PAPER No. 241

CONSTRUCTION OF A BRIDGE OVER THE SOHAN  
AT DHOKPATHAN

BY GANPAT RAI NANGEA, A.M.I.E. (IND.), A.M.I. STRUCT. E.,  
ASSISTANT ENGINEER, P.W.D. (BUILDINGS AND ROADS)

PHOTO NO. 6.—DHOKPATHAN BRIDGE.  
A view of sagged girder of Span No. 3 after the flood of 19-6-1940

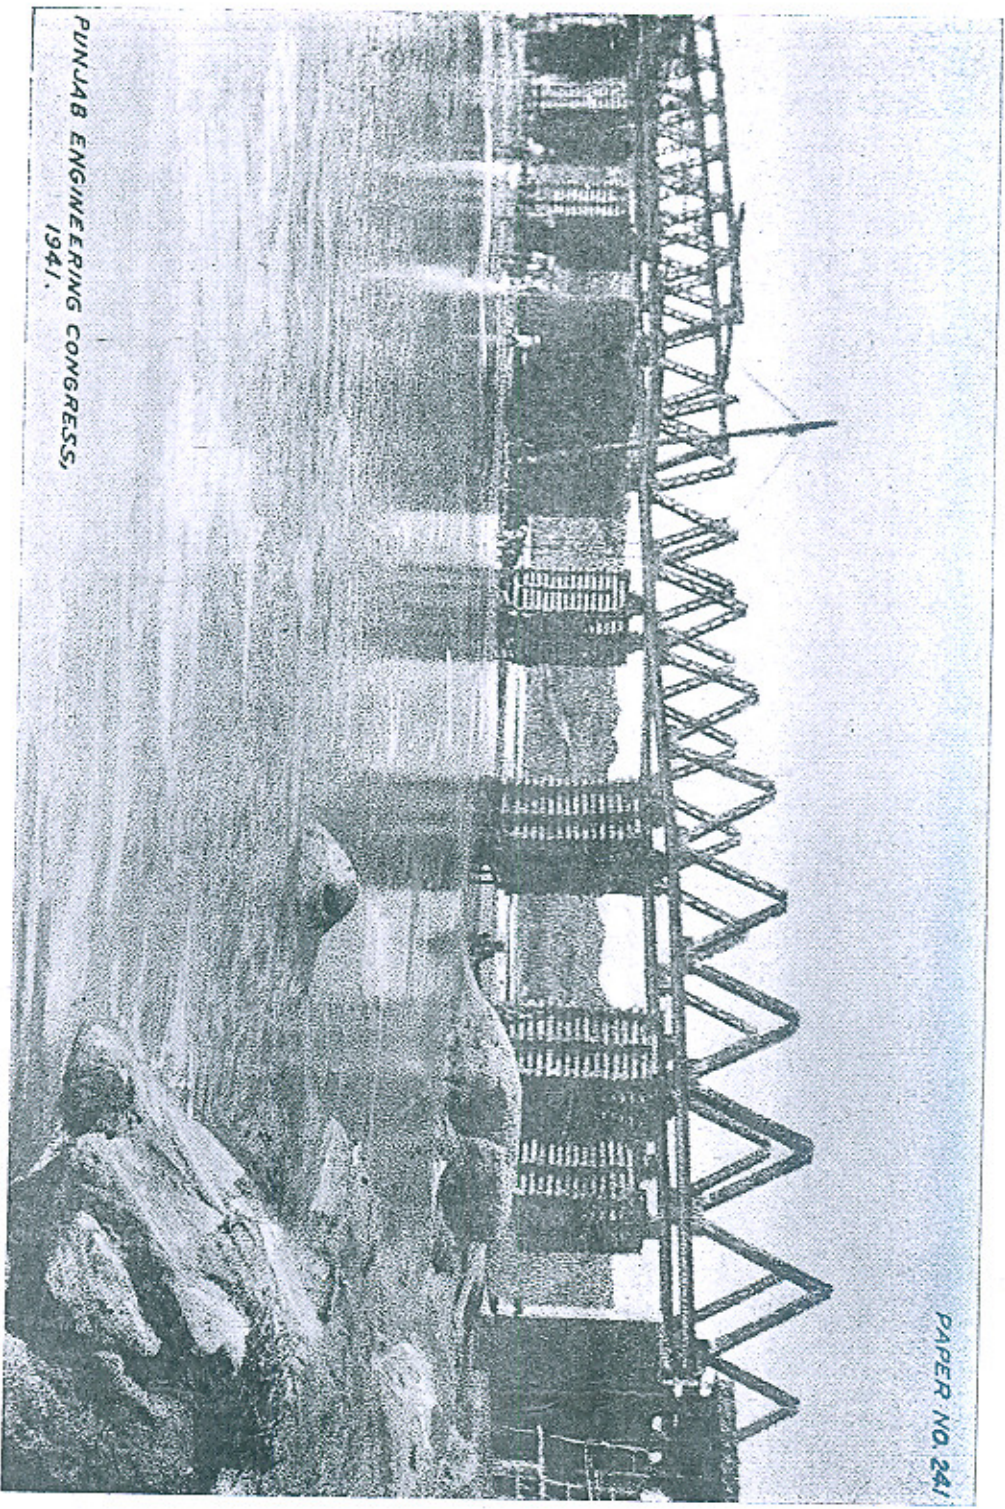
He further added that it was stated that during the floods the bottom boom of one of the spans got sagged and questioned whether it was correct to straighten up and re-use a number which had been once over-stressed. He stated that in Appendix A the value of shear worked out was incorrect, because the Indian Roads Congress loading required that for calculation of shear the distributed live load shall be 0.34 ton per ft. run even for spans smaller than 20 ft., plus a knife edge load of 9 tons and that a correct interpretation of the loading would have resulted in about 20 per cent. economy in cost of decking.

About his remarks on the over stressing of members of Span No. 3, the Author related the description of the event again; the bottom booms had been placed and only a few (less than 5 per cent.) half-tight bolts were in position. Under the circumstances, he doubted if there could be any question of overstressing of the members under their own weight.
